EVALUATION OF CHANNEL HEAD FLAW GROWTH
BY CORROSION FATIGUE

CONSOLIDATED EDISON INDIAN POINT UNIT NO. 3
STEAM GENERATOR
CHANNEL HEADS

ENCLOSURE 2

CONCEPTUAL SKETCH VALVE OPERATOR RELOCATION - SIS VALVES

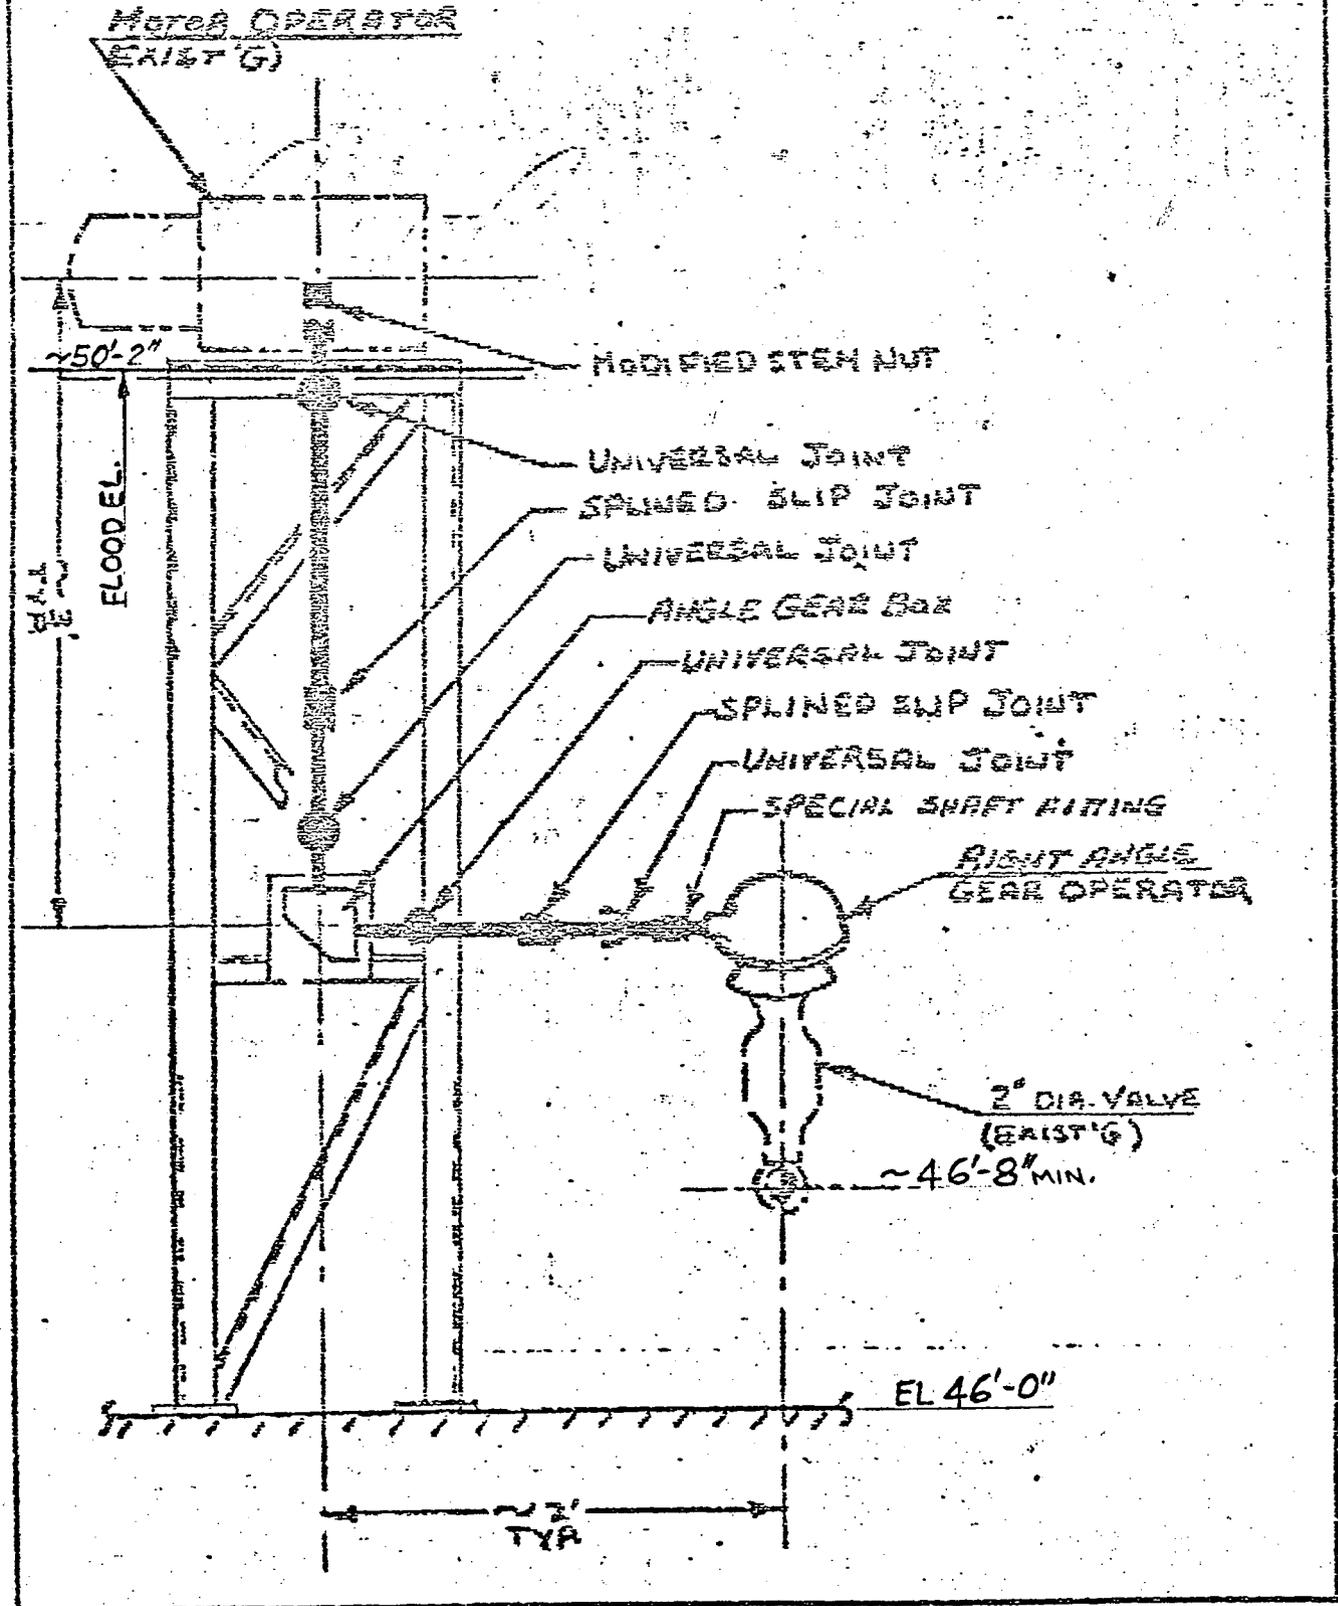
At approximately 21 hours after the postulated loss-of-coolant accident, hot leg recirculation will be initiated in order to assure that boric acid concentration in the core does not reach unacceptable levels. To establish hot leg recirculation in each high-head safety injection train, two of the four cold leg injection paths must close and the hot leg injection path open. To effect this realignment, the motor operator on Valves 856B, C, E, G, H and J

will be relocated remote from the valve to a position above Elevation 51'0". The valves will be operated via a positive mechanical drive arrangement which incorporates flexibility by use of splined couplings and universal joints. A conceptual sketch of the valve operator relocation is shown in Figure 1. The frame supporting the valve operators will be designed as a seismic Class 1 structure.

- (a) Relocate the motor operator on Valves 856B, C, E, G, H and J.
- (b) De-energize the valves listed below at their motor control center in the position indicated.

SO. 247-305	Westinghouse Electric Corporation F.P. 9321-05		
	TITLE CONSOLIDATED EDISON CO. 3307		
1	INDIAN POINT STATION - UNIT NO 3		500B971
	ELEMENTARY WIRING DIAG. MOTOR OPERATED VALVE		
SUB	PH. ARN	NO. 302	SHEET-155
	ATOMIC POWER DIV.		
		PITTSBURGH, PA. U.S.A.

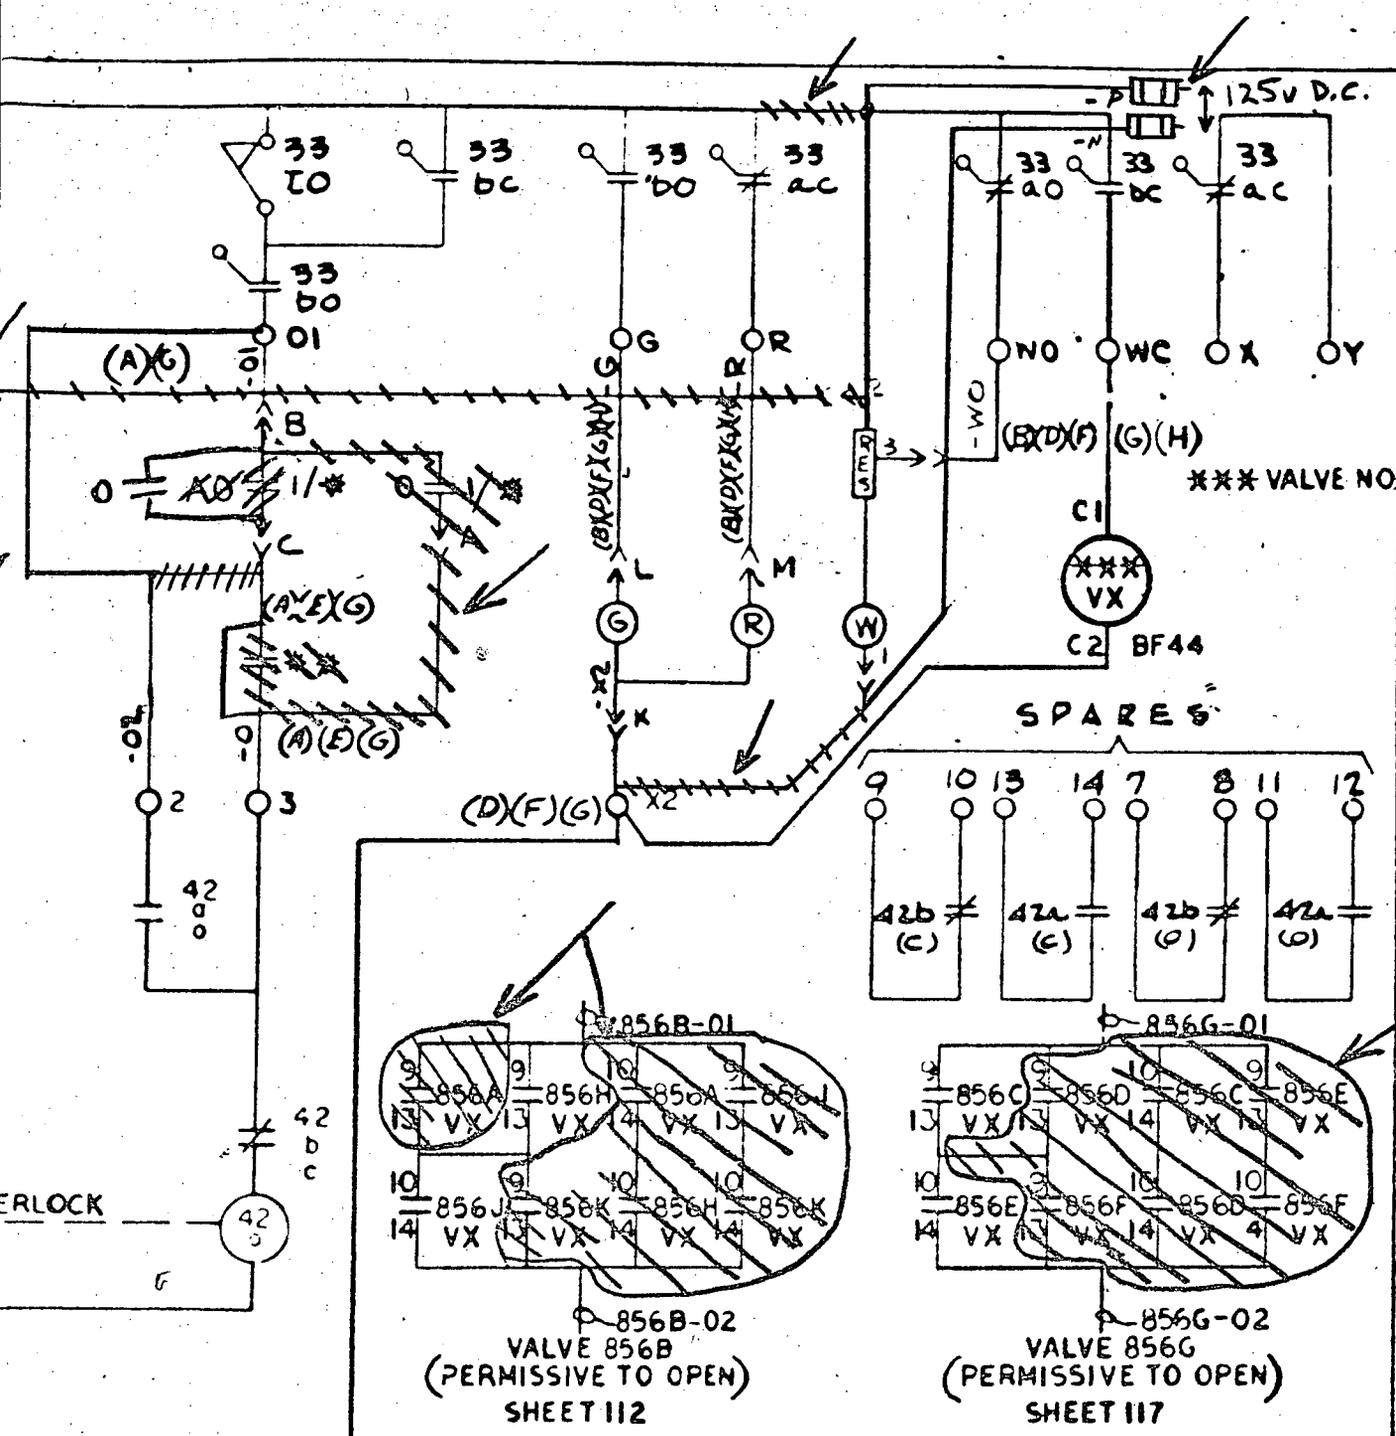
Attached is a copy of the affected electrical schematics (500B971 sheets 112, 117 and 155) marked up to reflect the proposed design changes.

→ WORK CHANGES AS MARKED WITH REV 2

Westinghouse Electric Corporation
INDIAN POINT STATION UNIT NO. 3
CONSOLIDATED EDISON
ELEMENTARY WIRING DIAG. VALVE TABLE-NOV
RWKEMERER
500B971
SHEET-117
PITTSBURGH, PA., U.S.A.

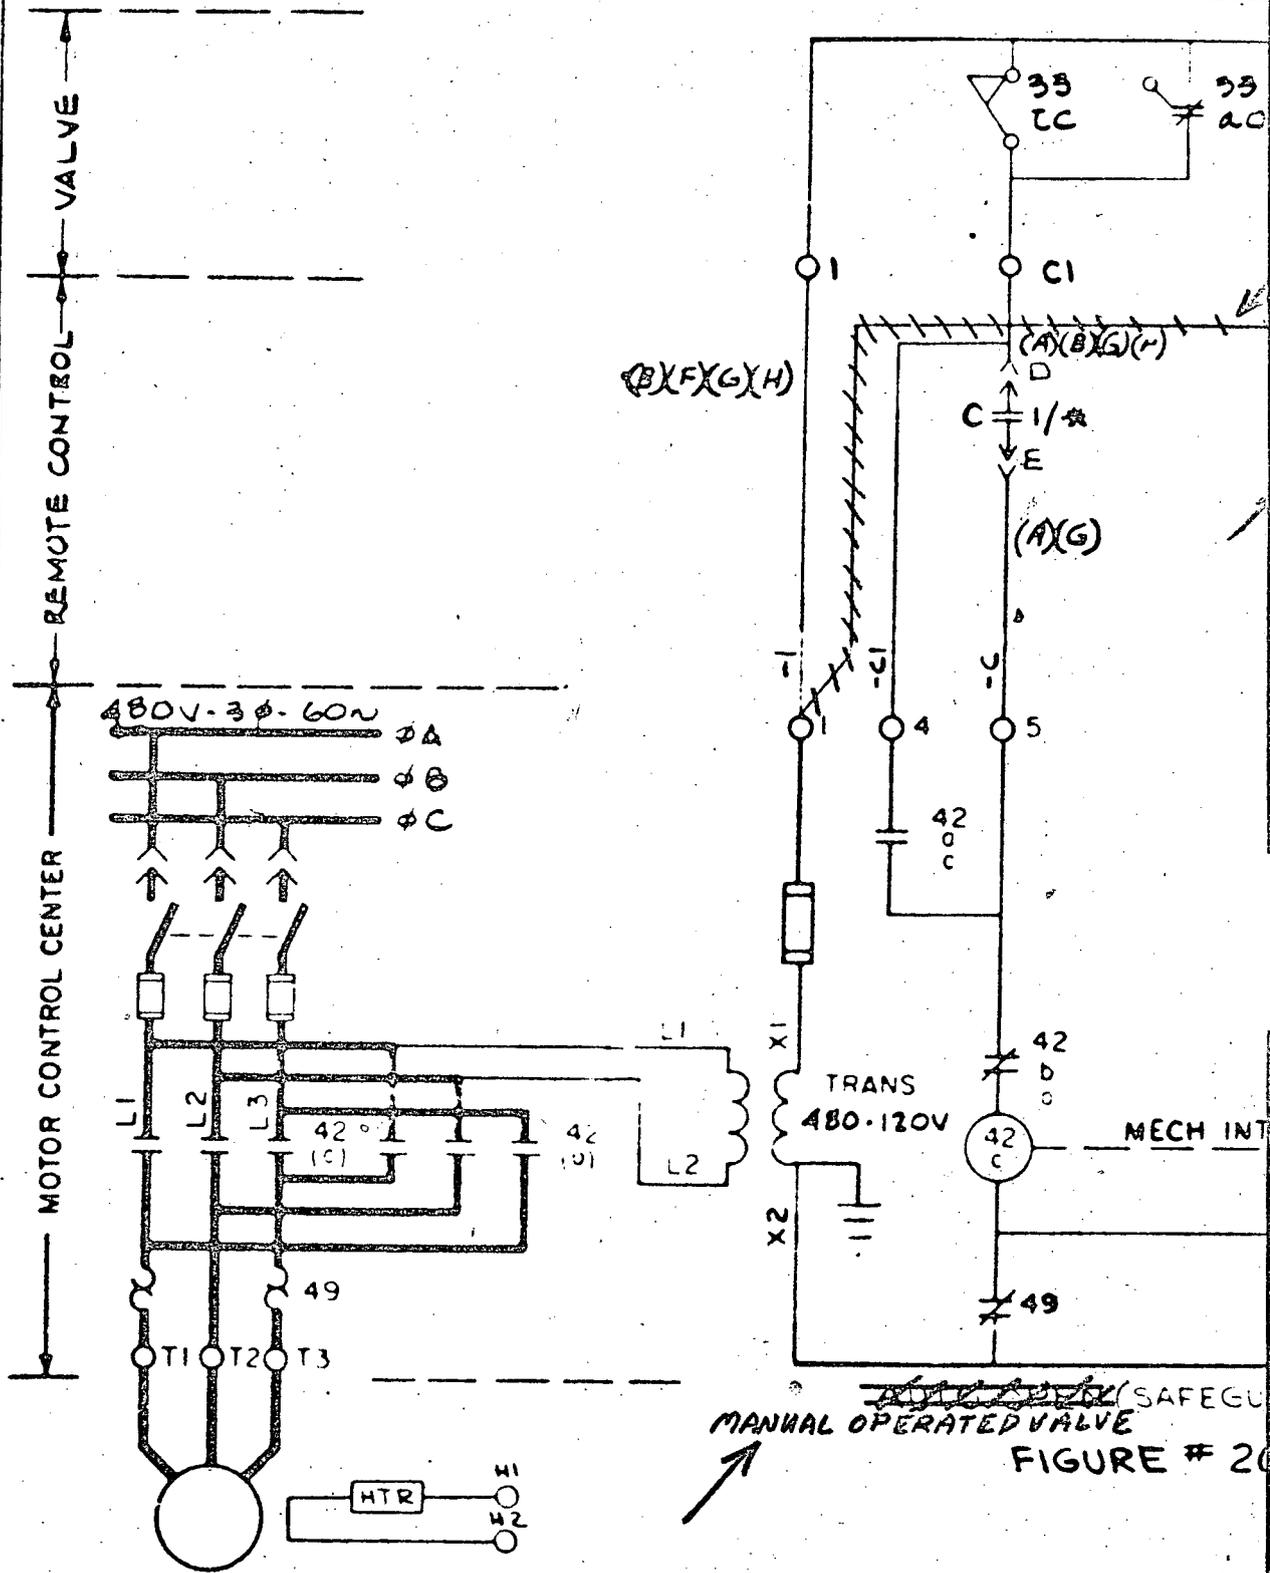
WORK CHANGES ALL MARKED
WITH REV 12
